APPLICATION NO.	FILING DATE	FIRST NAMED INVENTOR	ATTORNEY DOCKET NO.	CONFIRMATION NO.
10/066,087	01/30/2002	Benjamin C. Rivera	JPS 756.712	2441
152	7590	12/19/2005	EXAMINER	
CHERNOFF, VILHAUER, MCCLUNG & STENZEL			SHAKERI, HADI	
1600 ODS TOWER			ART UNIT	
601 SW SECOND AVENUE			PAPER NUMBER	
PORTLAND, OR 97204-3157			3723

Office Action Summary	Application No. 10/066,087	Applicant(s) RIVERA, BENJAMIN C.	
	Examiner Hadi Shakeri	Art Unit 3723

DETAILED ACTION

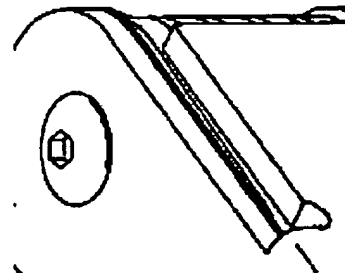
first channel wall in a first direction away from said channel, said first external flange including an integral first leaf spring, said first leaf spring forming a portion of said first elongate side of said outer margin.

Regarding claim 99, Taggart et al. meets the limitation, i.e., wherein the portion of the flange that forms the spring is separated from an adjacent portion of the channel wall by a cut in the channel wall (at the upper edge).
